Job:
Proposed extension at:
3, Wiltshire Drive,
Wokingham,
Berkshire.
RG40 1TQ

Amended Plans

Drwg:
Proposed Ground Floor Plan

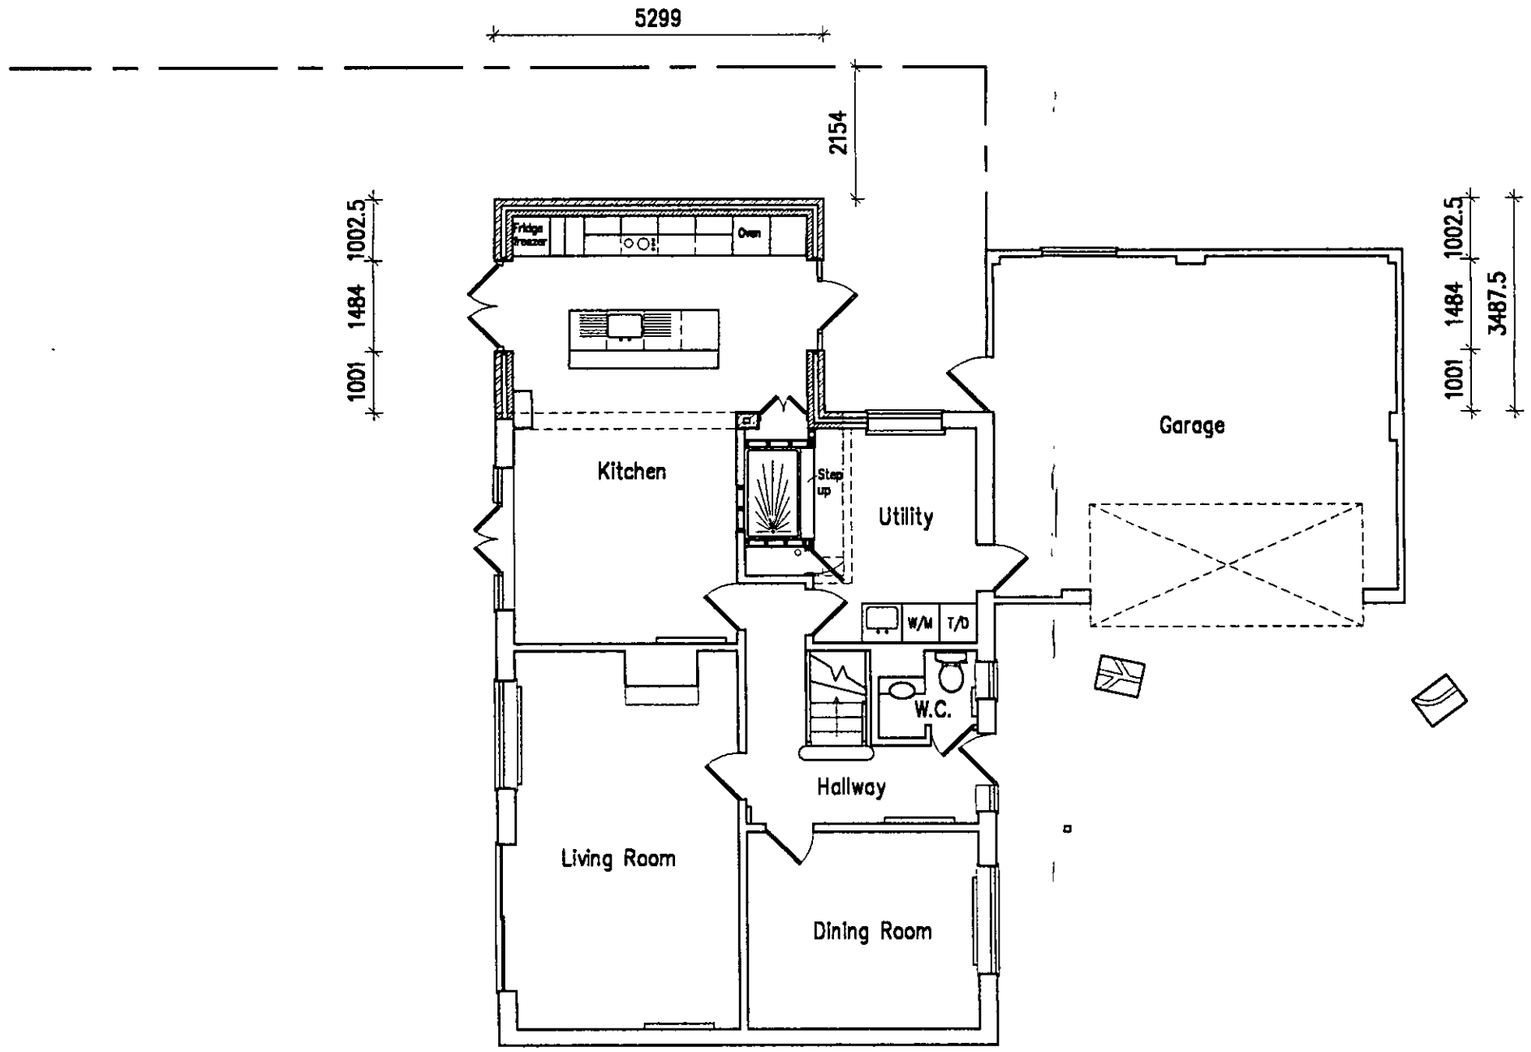
AMENDMENT SCHEDULE		
Date	No.	Description
21.11.02	1	Western window to kitchen area replaced with french doors

Drwg: Proposed First Floor Plan

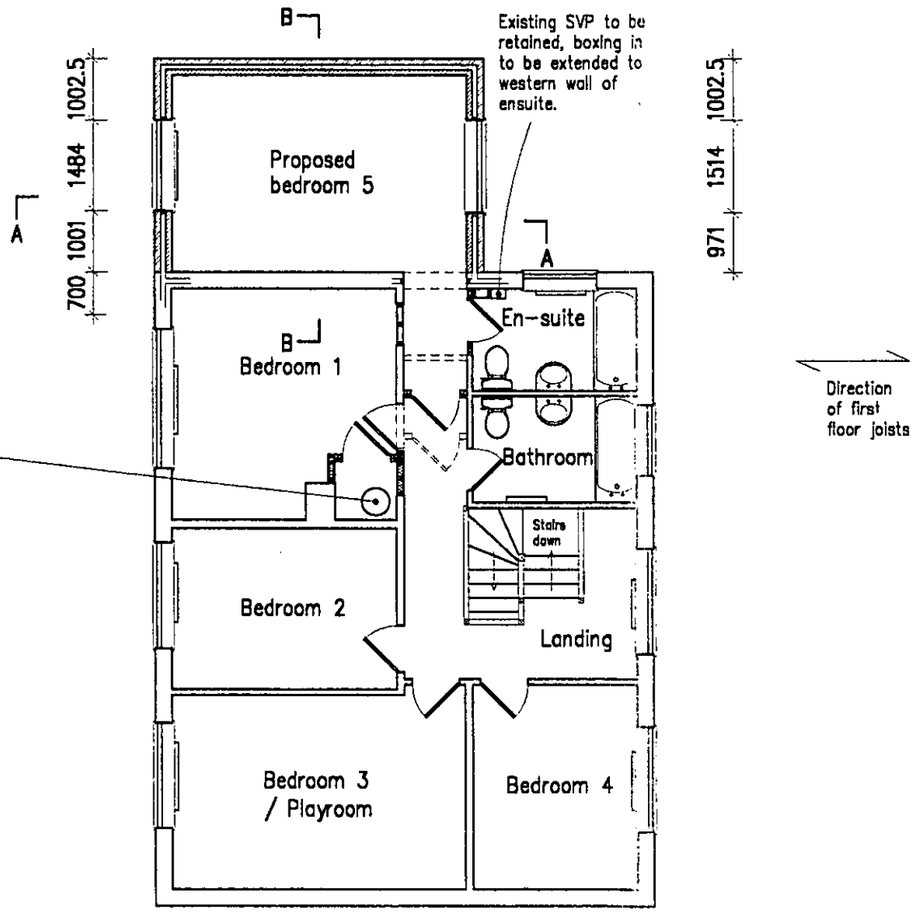
AMENDMENT SCHEDULE		
Date	No.	Description
03.03.03	1	Front window to Bed 5 widened to 1370mm. Partitioning within Bed 1 altered. Bathroom layouts altered.
14.03.03	2	Single steel beam spans width of extension with intermediate support from brick pier.
22.03.03	3	Work to en-suite and bathroom sanitaryware omitted. SVP relocated externally. Wardrobe & assoc. steel beam omitted. Front window to bedroom 5 widened to 1514mm

Drwg: Prop. North/South Elevations

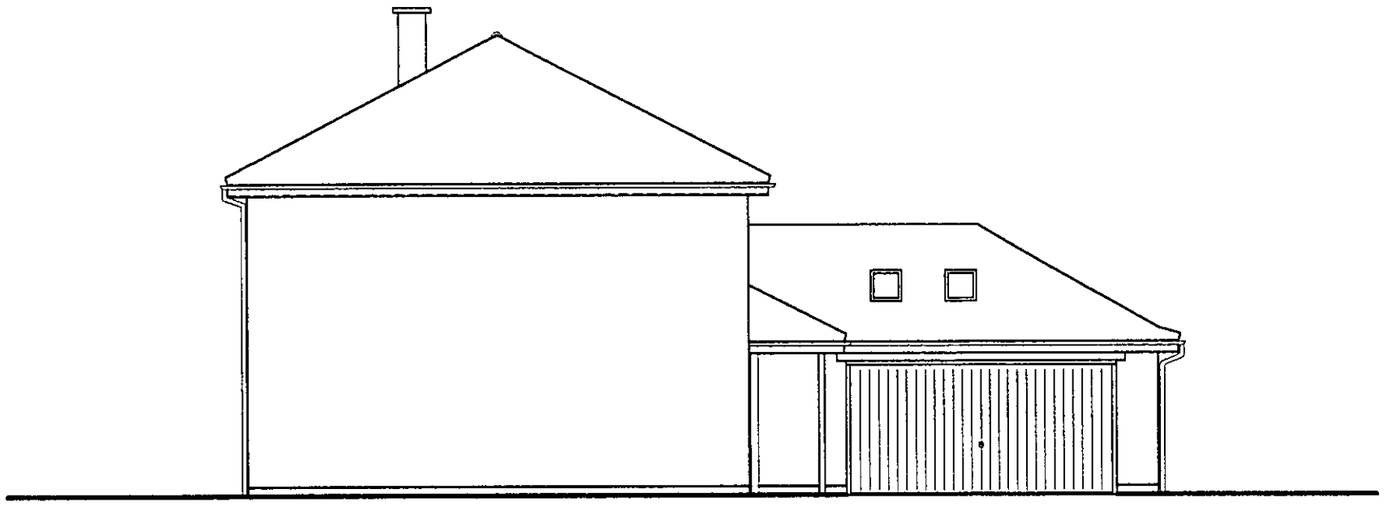
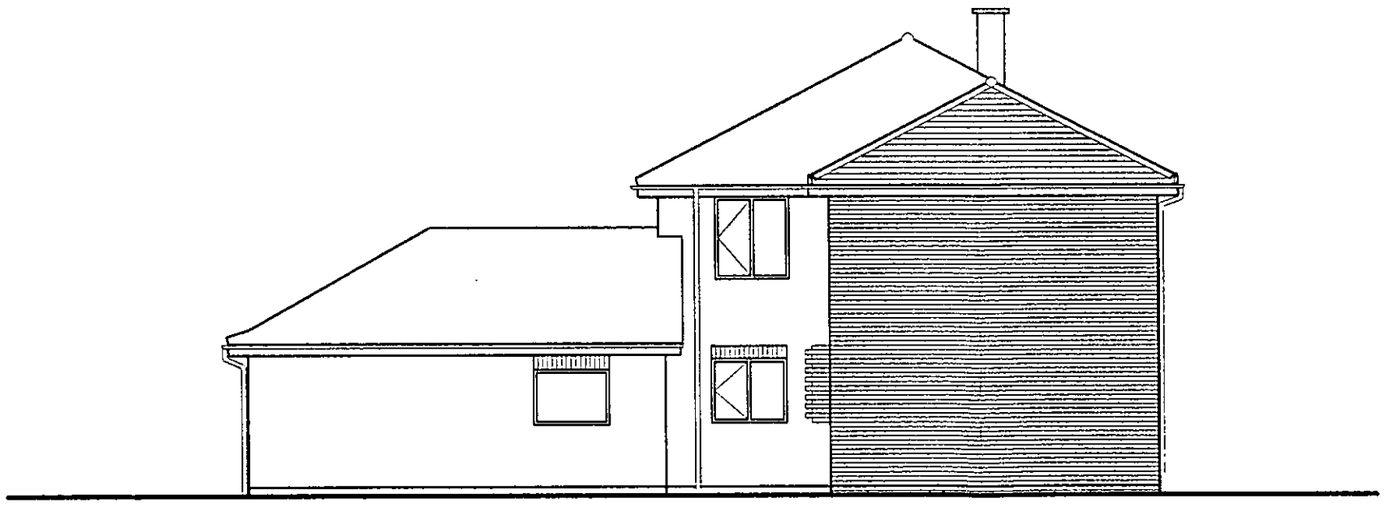
Date	No.	Description
21.05.03	1	Omit round window to bed 3

Drwg: Prop. East/West Elevations

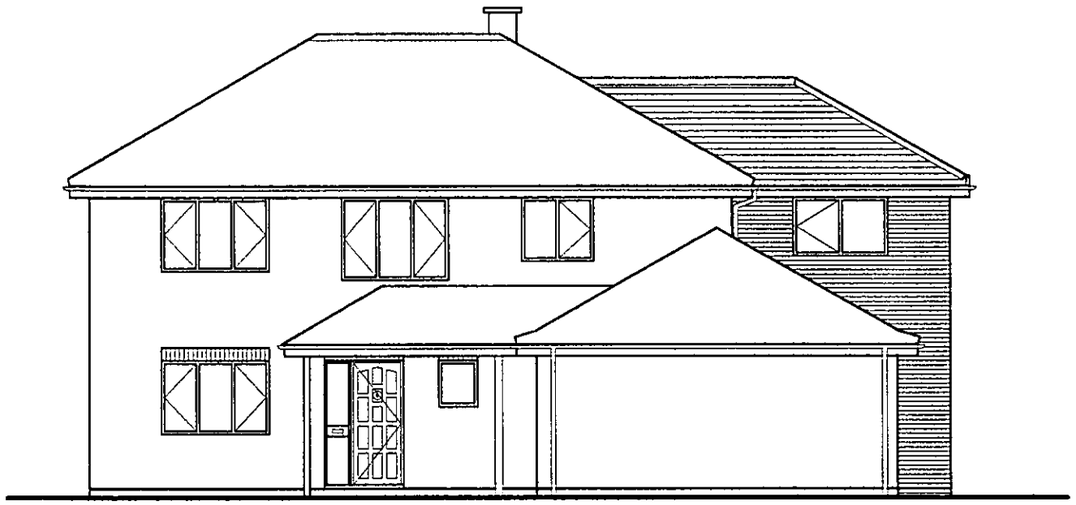
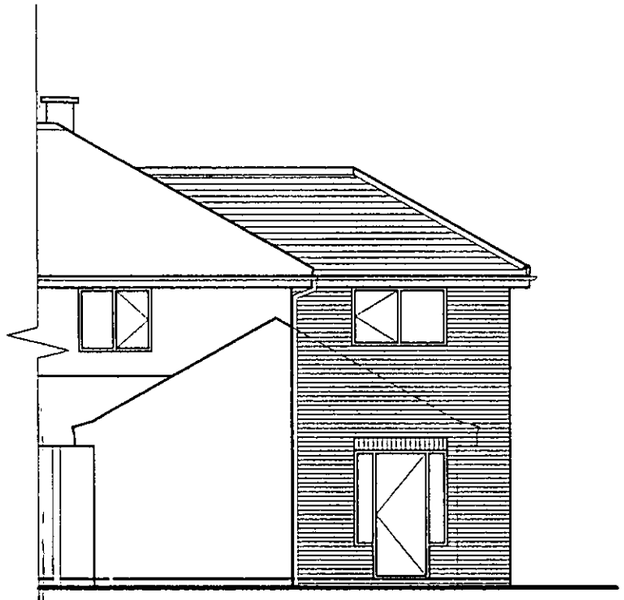
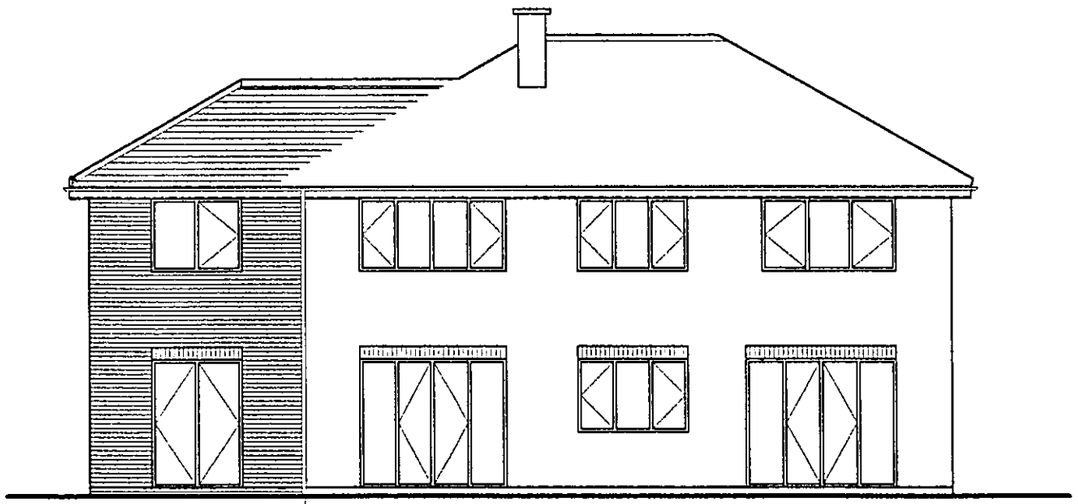
AMENDMENT SCHEDULE		
Date	No.	Description
03.03.03	1	Lounge patio door to rear changed to french casement.
		Proposed bedroom 5 front window changed to
		1050 x 1370mm.
21.05.03	2	Proposed bedroom 5 front window changed to
		950 x 1514mm.

Drwg: Proposed First Floor Plan

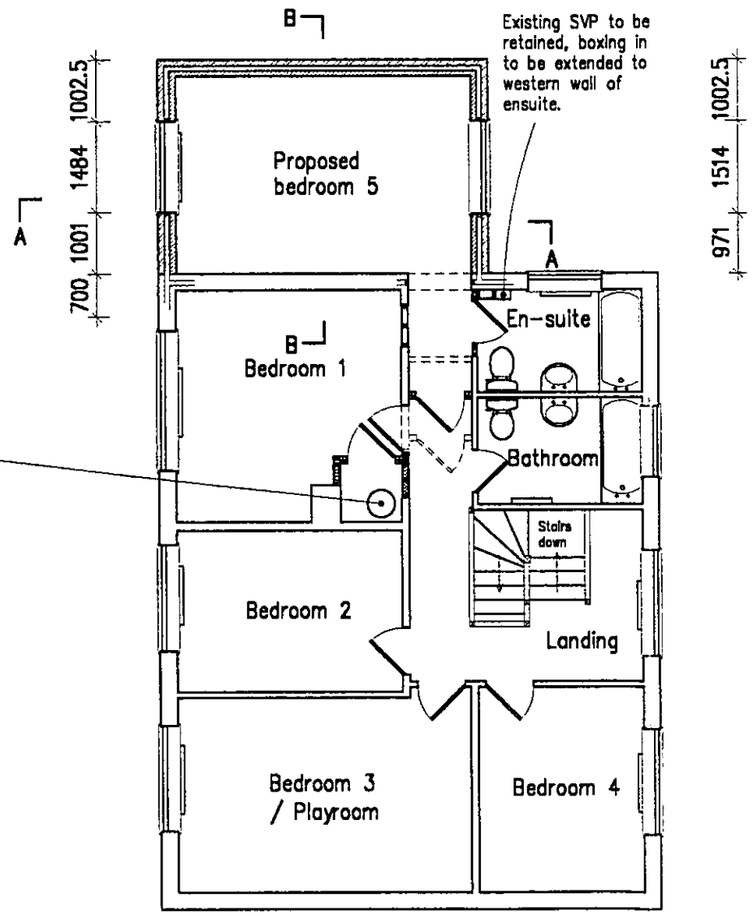
AMENDMENT SCHEDULE		
Date	No.	Description
03.03.03	1	Front window to Bed 5 widened to 1370mm. Partitioning within Bed 1 altered. Bathroom layouts altered.
14.03.03	2	Single steel beam spans width of extension with intermediate support from brick pier.
22.03.03	3	Work to en-suite and bathroom sanitaryware omitted. SVP relocated externally. Wardrobe & assoc. steel beam omitted. Front window to bedroom 5 widened to 1514mm.

Drwg: Prop. North/South Elevations

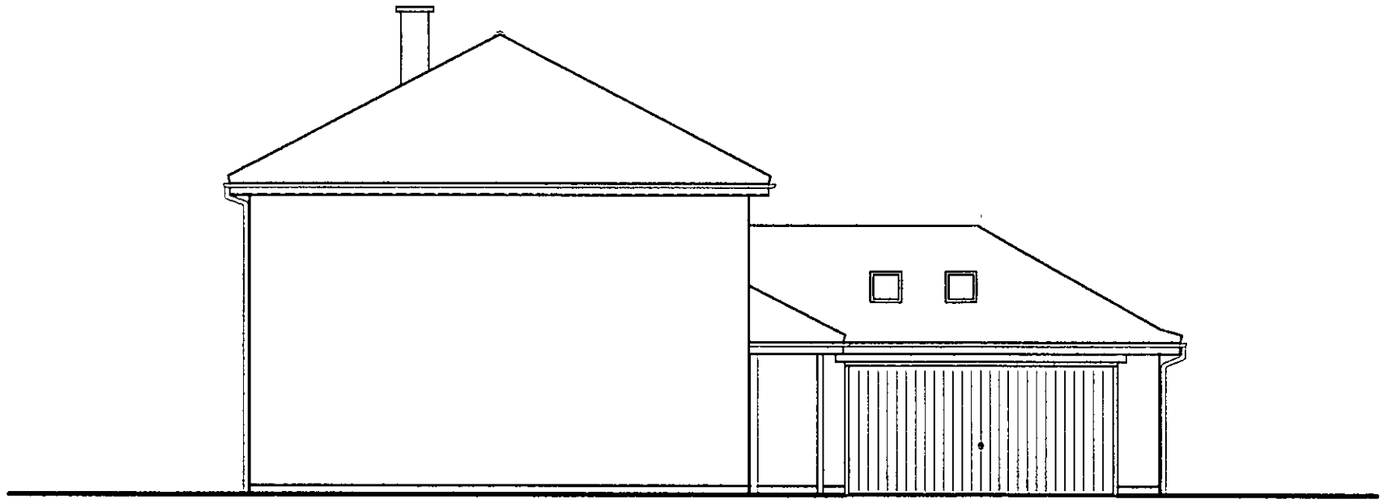
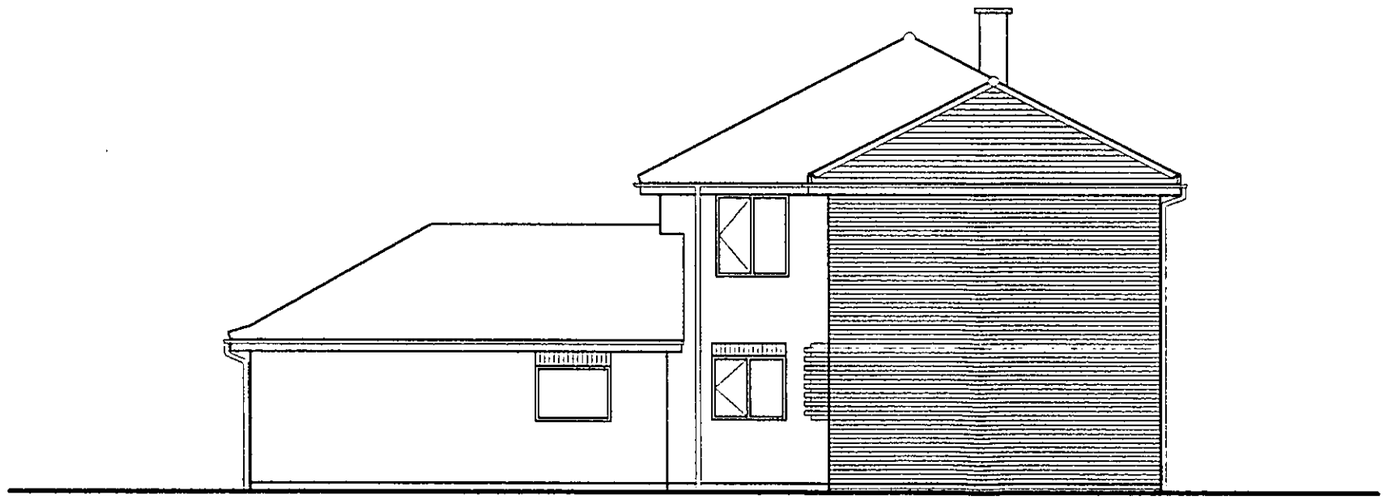
AMENDMENT SCHEDULE		
Date	No.	Description
21.05.03	1	Omit round window to bed 3

Drwg: Prop. East/West Elevations

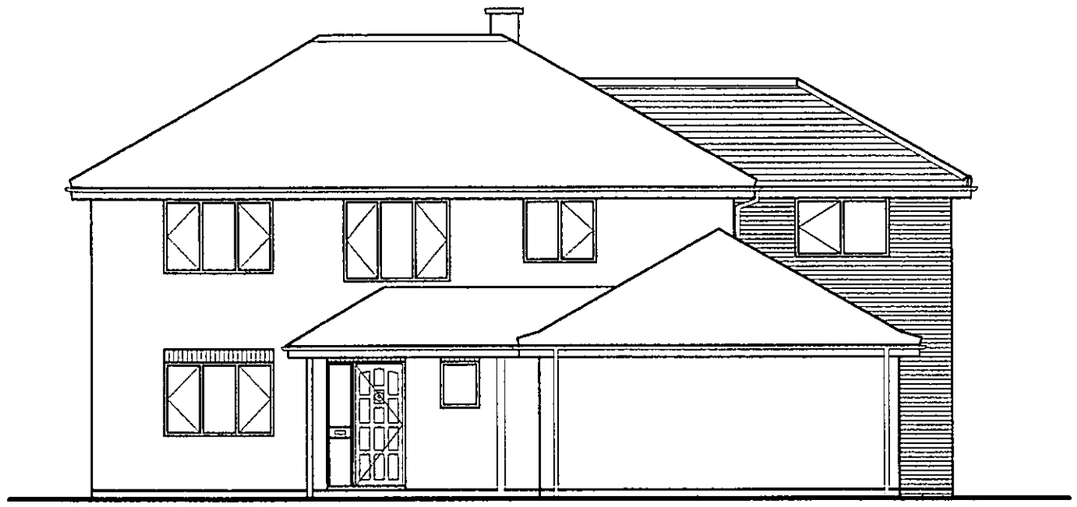
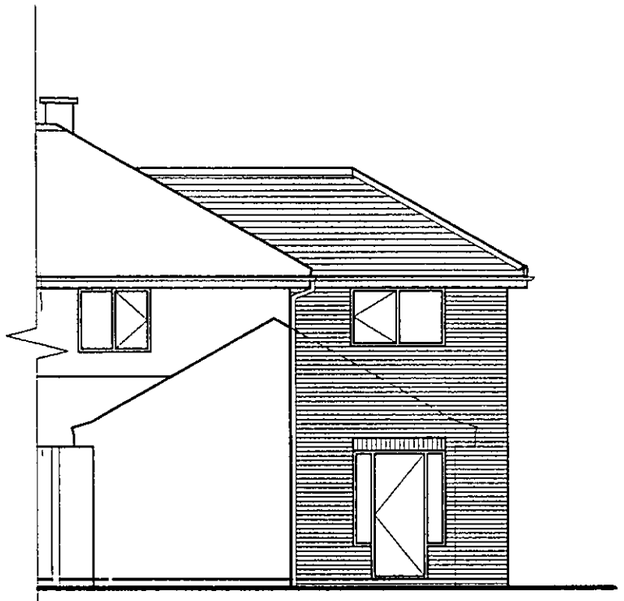
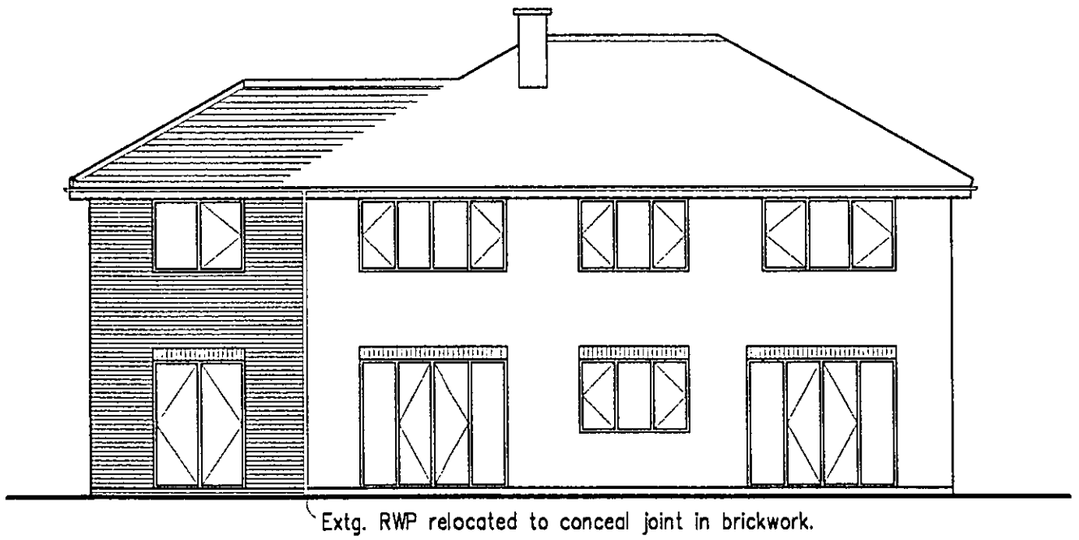
AMENDMENT SCHEDULE		
Date	No.	Description
03.03.03	1	Lounge patio door to rear changed to french casement.
		Proposed bedroom 5 front window changed to
		1050 x 1370mm.
21.05.03	2	Proposed bedroom 5 front window changed to
		950 x 1514mm.

Drwg: Proposed First Floor Plan

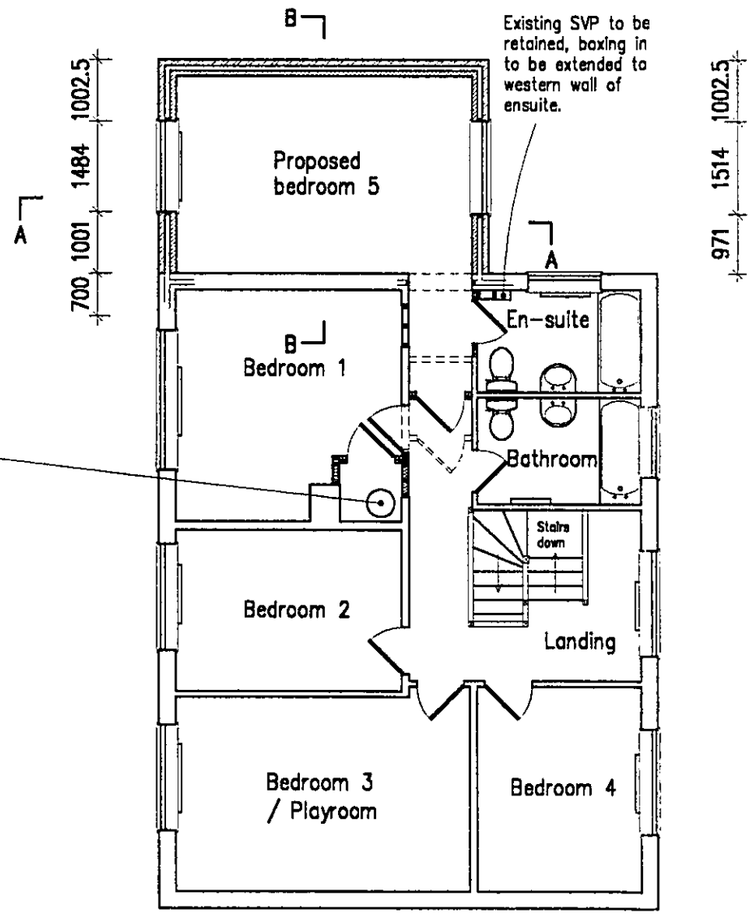
Date	No.	Description
03.03.03	1	Front window to Bed 5 widened to 1370mm. Partitioning within Bed 1 altered. Bathroom layouts altered.
14.03.03	2	Single steel beam spans width of extension with intermediate support from brick pier.
22.03.03	3	Work to en-suite and bathroom sanitaryware omitted. SVP relocated externally. Wardrobe & assoc. steel beam omitted. Front window to bedroom 5 widened to 1514mm.

Drwg: Prop. North/South Elevations

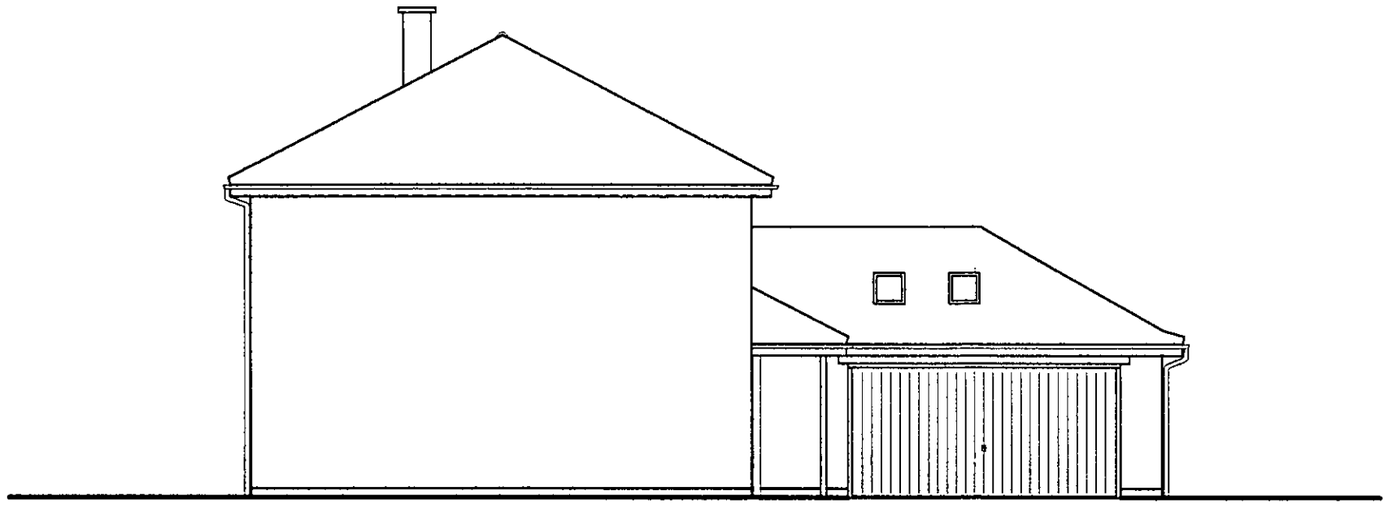
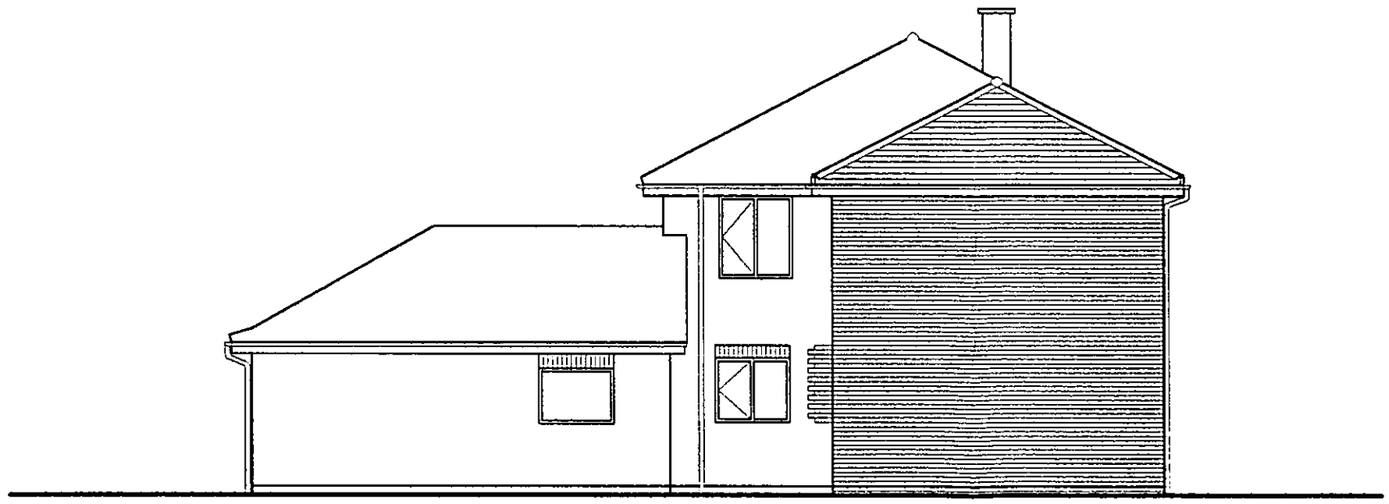
AMENDMENT SCHEDULE		
Date	No.	Description
21.05.03	1	Omit round window to bed 3
